DCUSA Change Report		At what stage is this document in the process?
<h1>DCP 305:</h1> <h2>LDNO Boundary Level Definitions in the EDCM</h2> <p>Date Raised: 12th July 2017</p> <p>Proposer Name: Andrew Enzor</p> <p>Company Name: Northern Powergrid</p> <p>Company Category: DNO</p>		01 – Change Proposal
		02 – Consultation
		03 – Change Report
		04 – Change Declaration
<p>The intent of this change proposal is to amend the definitions and application of DNO/LDNO boundaries under the EDCM to avoid instances of double and/or non-charging for certain assets.</p>		
 	<p>The Workgroup recommends that this Change Proposal should:</p> <ul style="list-style-type: none"> • proceed to Change Report <p>Parties are invited to consider the proposed amendments (Attachment 1) and submit their votes using the Voting form (Attachment 2) to dcusa@electralink.co.uk by 17 April 2018</p> <p>The voting process for the proposed variation and the timetable of the progression of the Change Proposal (CP) through the DCUSA Change Control Process is set out in this document.</p> <p>DCP 305 has been designated as a Part 1 Matter as this change will impact both Distributor and Supplier Parties through amendments to t

Figure 1 – LDNO Network with one Designated EHV Property only

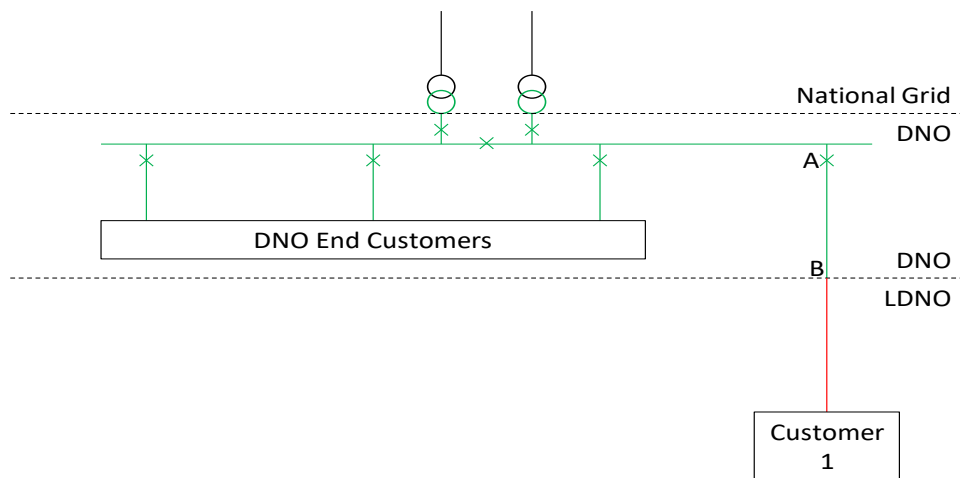
- 3.5 This results in the DNO applying the customer category at the point where assets for the sole use of the LDNO network meet the remainder of the DNO network, and so only charging fixed charges in respect of assets for the sole use of the LDNO network.
- 3.6 For example, consider an LDNO taking a supply from a dedicated DNO 132kV cable from a Grid Supply Point (GSP) (i.e. where the DNO 132kV cable is for the sole use of the LDNO network) and supplying one customer which is a Designated EHV Property through its system, as shown in Figure 1.

- 3.7 When calculating a boundary equivalent tariff, the DNO would assign the customer category 'by reference to the Point of Common Coupling' (clause 24.6) marked as point 'A' in Figure 1, i.e. 0000 – 'Point of Common Coupling at the GSP, whether the GSP is shared or not', and so the customer would be charged for the DNO 132kV cable from point 'A' to point 'B' as a sole use asset only.
- 3.8 Now consider another customer which is a Designated EHV Property (or indeed any other connectee) connecting to that LDNO network, as shown in Figure 2.

- 3.10 DCP 305 seeks to resolve this issue by amending the DCUSA legal text to treat Designated EHV Properties connected to LDNO networks in the same manner regardless of whether there is only a single customer or if there are multiple customers connected to that LDNO network, by setting the Point of Common Coupling to the Point of Common Coupling which would apply if the LDNO network in question were an end user in all cases.
